VEHICLE SAFETY DEFECT SERVICE BULLETIN
Recall Campaign 07V481000 US Units
Recall Campaign 07-345 CN Units
Monaco File # R07037

Re: Safety Recall – Villa Isri Air Base Seat

RECALL NUMBER
UNITED STATES • 07V481000
CANADA • 07-345
Air Suspension Seat Tether Installation

Figure 1

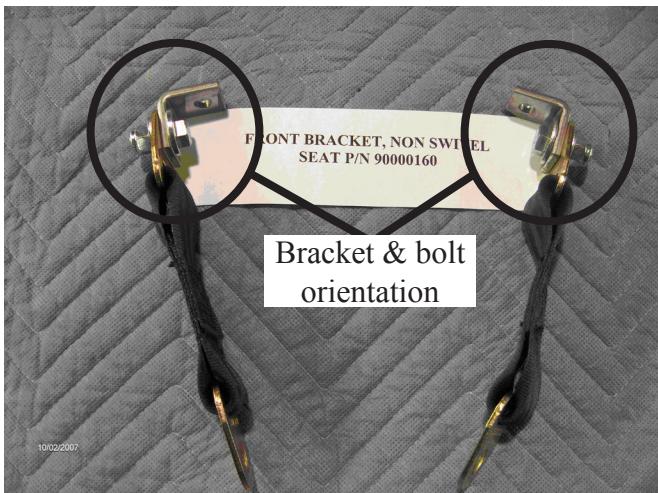
1. Pull skirt of seat up and secure with masking tape (*Figure 1*).
2. The tethers are attached from the adapter plate to the floor plate (*Figure 1*).
3. Assemble the brackets (P/N 90000160) to the tethers with the 3/8" bolt head to the inside (*Figure 2*).
4. Remove the nut and washer from the top front bolt. Install the bracket; reinstall the washer and nut on the bolt. The vertical leg of the bracket faces to the outside. Tighten the bolt and nut with two 1/2" wrenches (*Figure 3*).
5. The bottom bolt is a tight fit, but a 1/2" open-end wrench will fit inside the channel to hold the nut. Angle the belt up at about a 30-degree angle as you tighten. Install the tether on the other side of the seat in the same sequence (*Figure 4*).
6. Tethers installed (*Figure 5*).

Figure 6

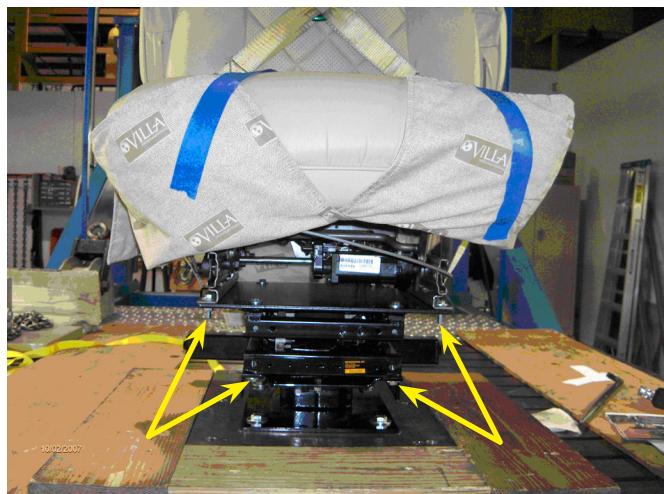
1. Pull skirt of seat up, and secure with masking tape (*Figure 6*).
2. The tethers are attached from the adapter plate to the top plate of the swivel riser (*Figure 6*).
3. Assemble the brackets (P/N 00002161) to the tethers with the 3/8" bolt head to the outside (*Figure 7*).
4. Remove the nut and washer from the top front bolt. Install the bracket; reinstall the washer and nut on the bolt. The vertical leg of the bracket faces to the inside. Tighten the bolt and nut with two 1/2" wrenches (*Figure 8*).
5. Remove the bolt and washer from the front of the riser and insert the tab from the tether (*Figure 9*).
6. Reinstall bolt and washer with tether and tighten. Install the tether on the opposite side of the seat in the same sequence (*Figure 9*).
7. Tethers installed (*Figure 10*).
